Re: Lawrence & Cynthia Caron
274 Richmond Road
Perpetual Offer of Dedication

ITEM #1

PROPOSED STORMWATER EASEMENT

3-LOT SUBDIVISION PRELIMINARY PLAT REPORT

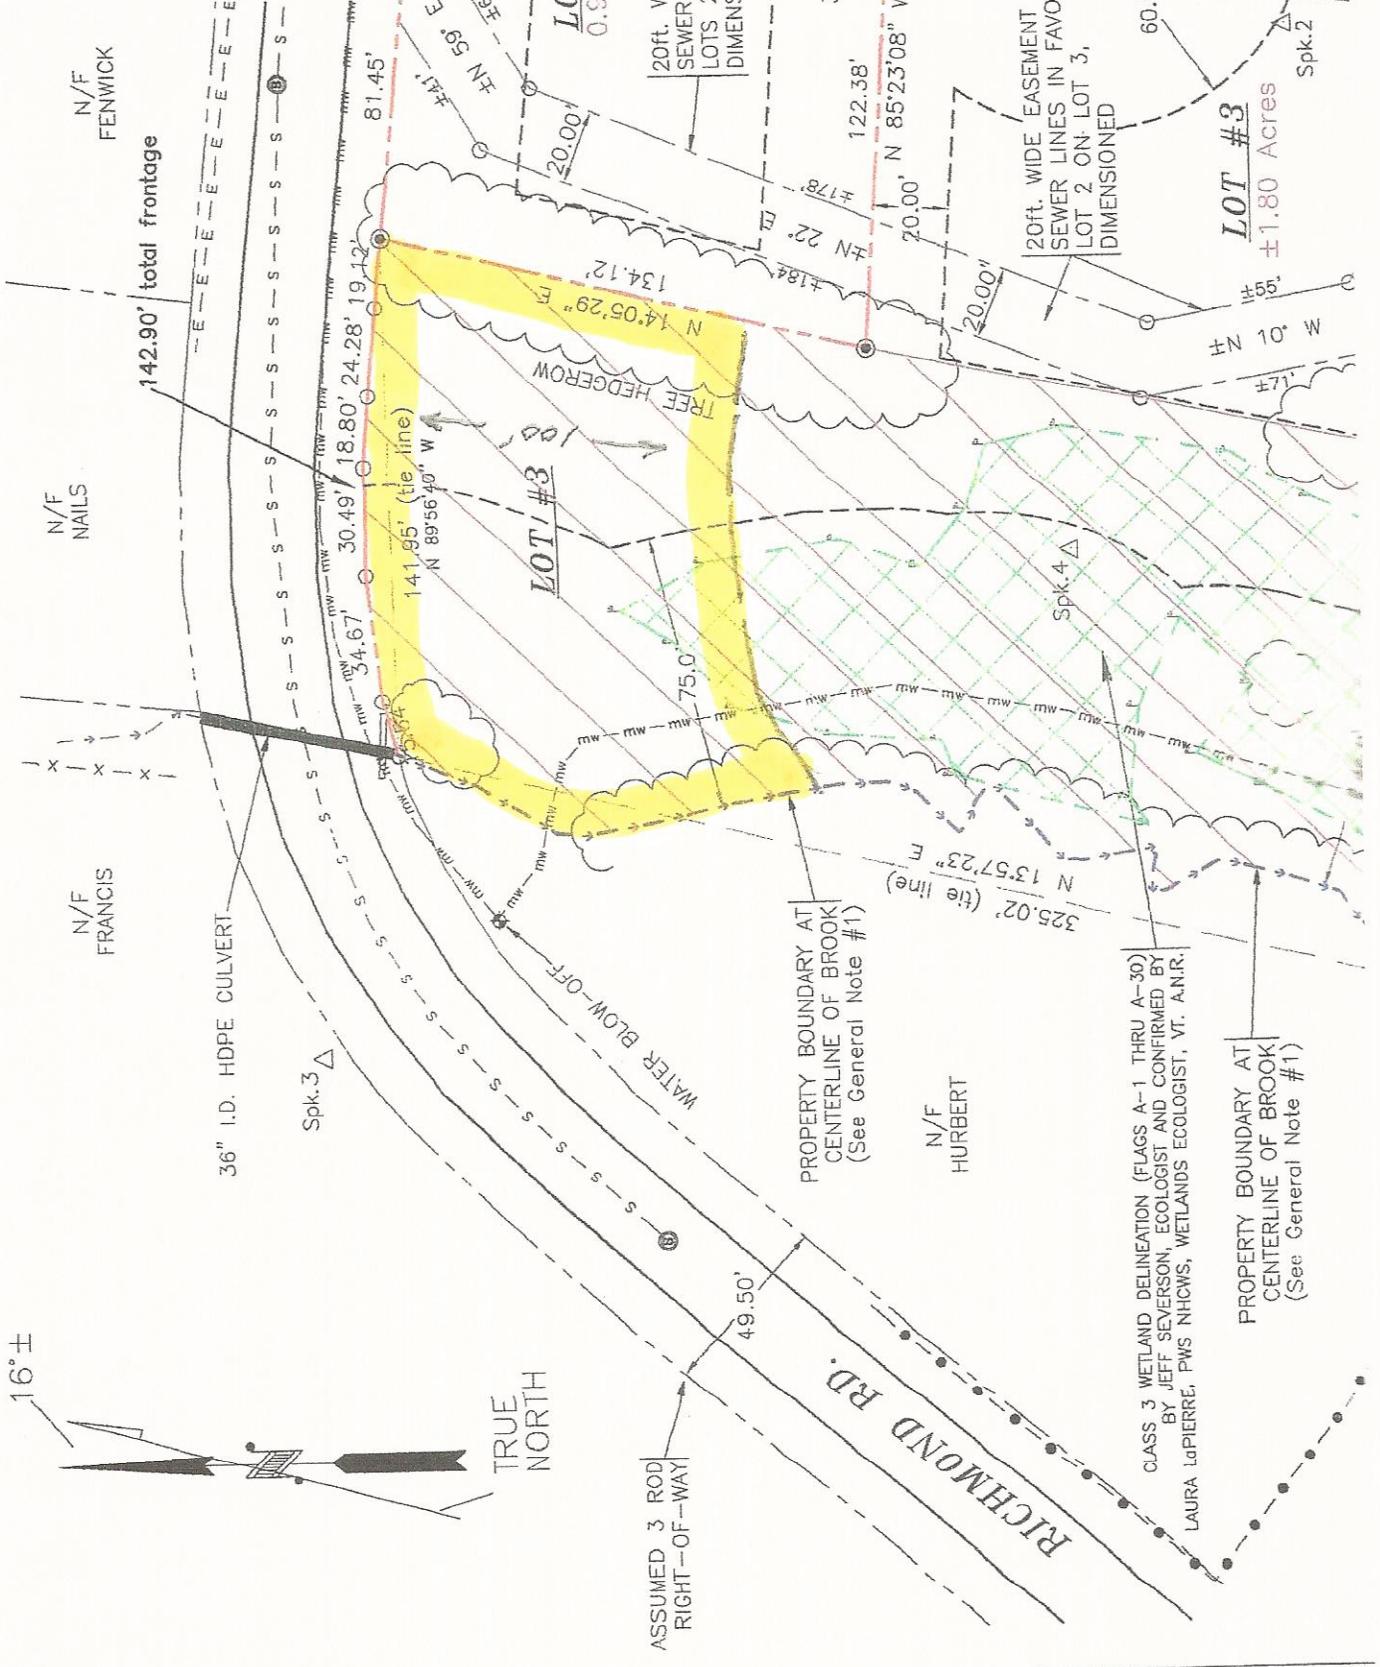
→ **Community Facility Size (section 4.5.8, Zoning)** – The proposed easement area for a future community facility (i.e., municipal stormwater control/treatment) should be enlarged. As

proposed, the easement area is only a 100' strip of land along the Richmond Road. As shown on the proposed stormwater easement map, additional land is available to the south that is within the open space area and unencumbered by the delineated wetland. I recommend the easement area be extended approximately 60' to the south to ensure that this future community facility has the necessary space, and so that the Town has more design flexibility.

To address these concerns, Lawrence & Cynthia Caron are willing to make a "Perpetual Offer of Dedication" for fee title to the Town of Hinesburg for more than half of what is currently designated as Lot #3. The area outline in yellow on Item #3 - "Proposed Stormwater Parcel" dated 7-24-14 shows Lot #3A as containing about 0.95 Acres. This will leave the remaining residential portion of Lot #3 with 0.85 Acres.
